Title: State Street Campus Garage Mixed-Use project

State Street Campus Garage Mixed-Use project  
415 N. Lake Street, Madison, WI 53715  
Land Use – UDC change in zoning from UMX to PD (GDP-SIP).  
EUA Project Number: 720448-01

## **Revised Content Addressing Comments Made by the Urban Design Commission**

3 EAST ELEVATION  
1/16" = 1'-0"

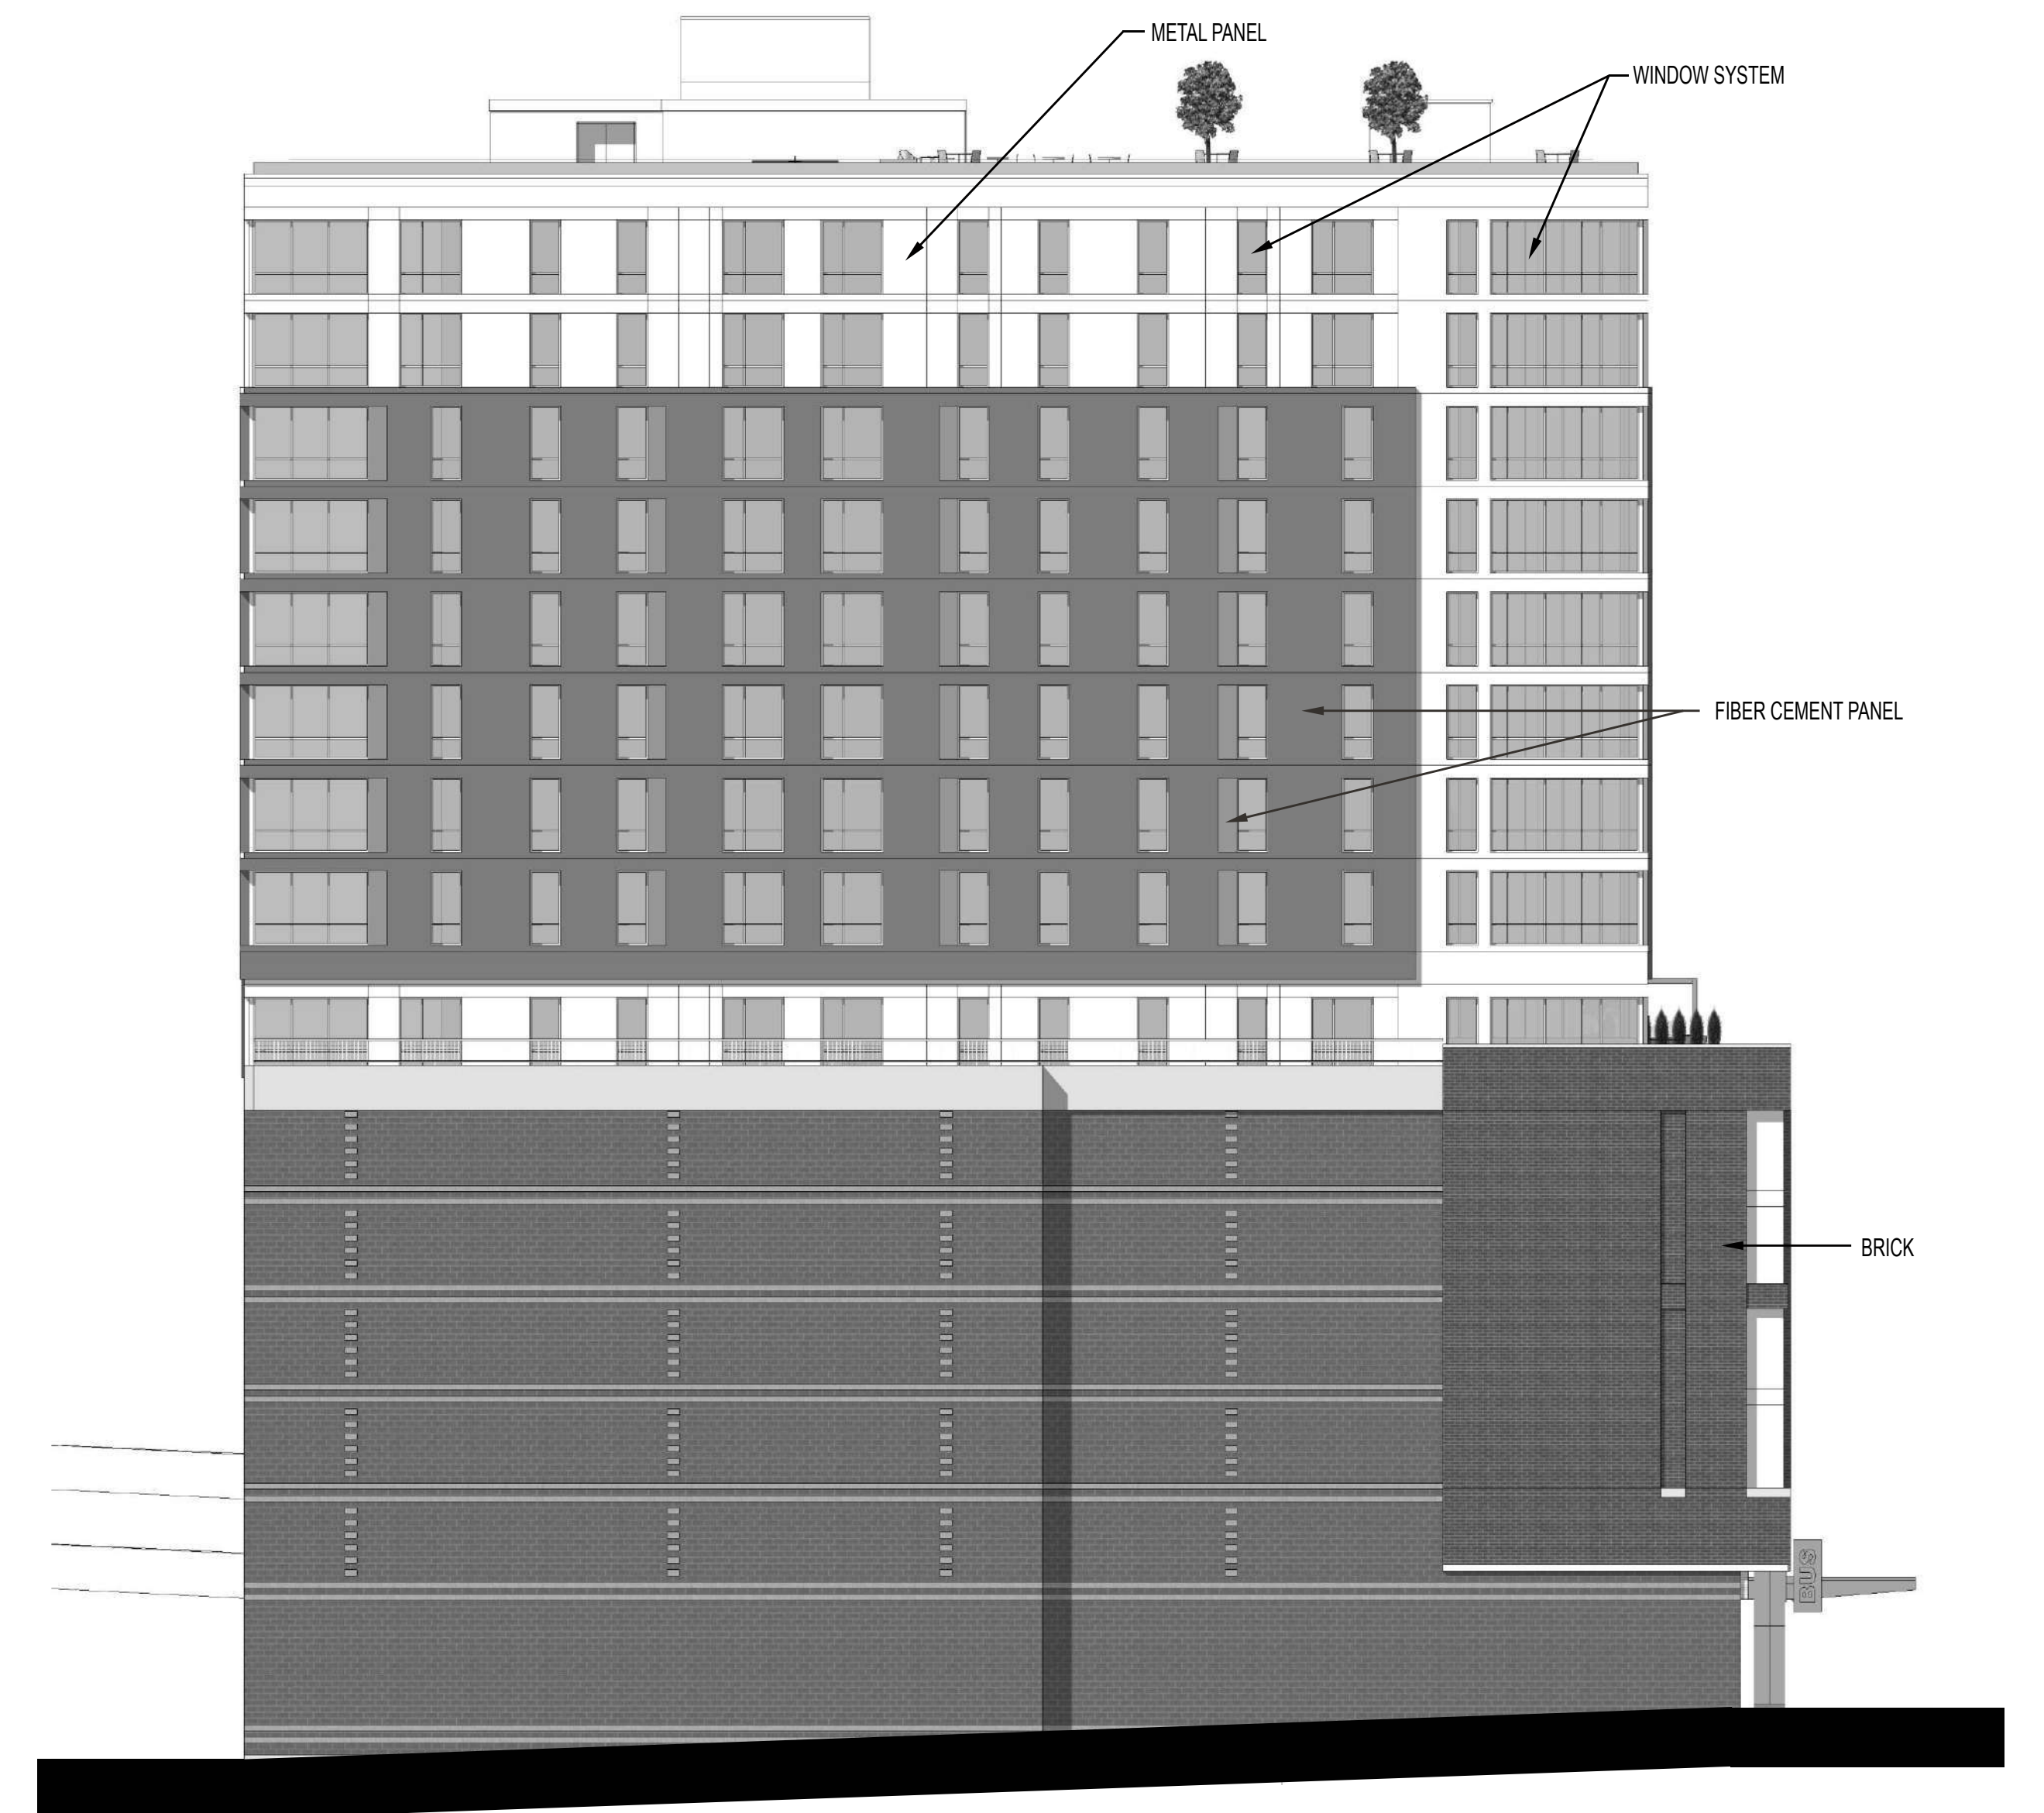
(Provide refinement of the level of design/articulation at the building corners and North/South elevations along Hawthorne Court and the exposed garage walls).

- Added design and material articulation to the north and south elevations.  
**(See Sheet A200)**
- The Hawthorne Court elevation will utilize the same burnished block that is being used on the other elevations. The two-colored block design feature on the north and south elevations will be utilized on the block areas of this elevation.  
**(See Sheet A200)**

**COLUMN DETAIL**

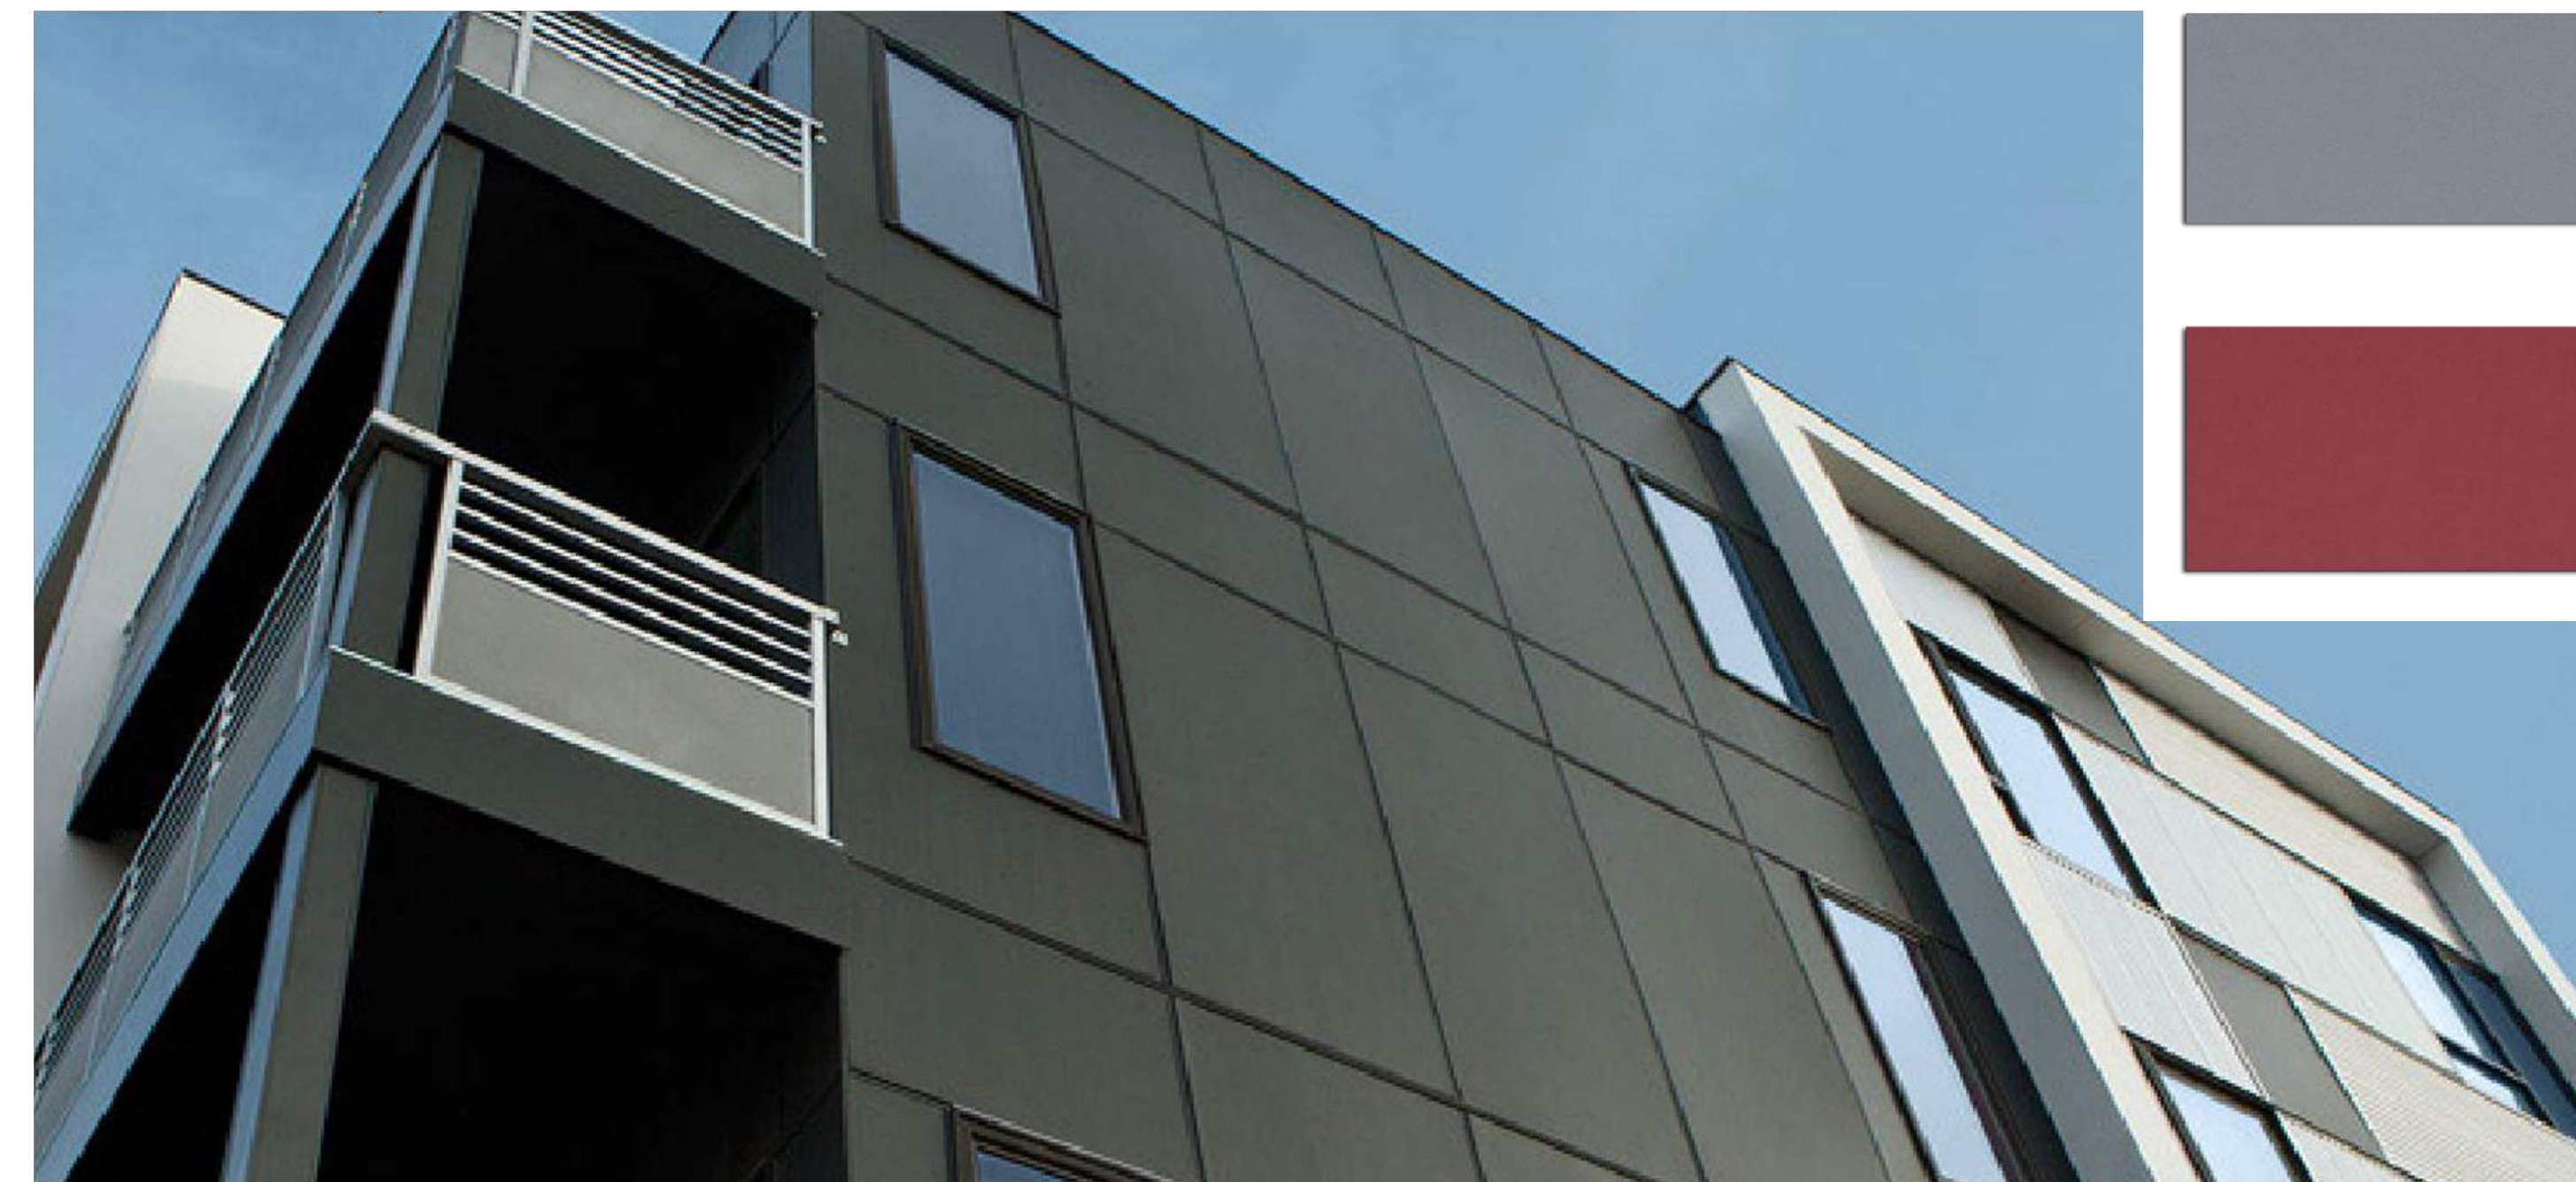
(Provide refinement of finish treatment of the columns, including material selection). This condition has been addressed as follows:

- The concrete columns will be wrapped with a pre-finished metal column enclosure. The enclosure will stop at the top of a concrete base to help maintain the integrity of the enclosure system.
- Added Lake Street, street level rendering and night rendering. These rendering illustrate the column wrap material.  
**(See Sheet A404 and A406)**
- Added an image of the column wrap material.  
**(See Sheet A500)**

Metal Wrapped Column Covers with Concrete Base  
Color: White (Image Shown in Silver)
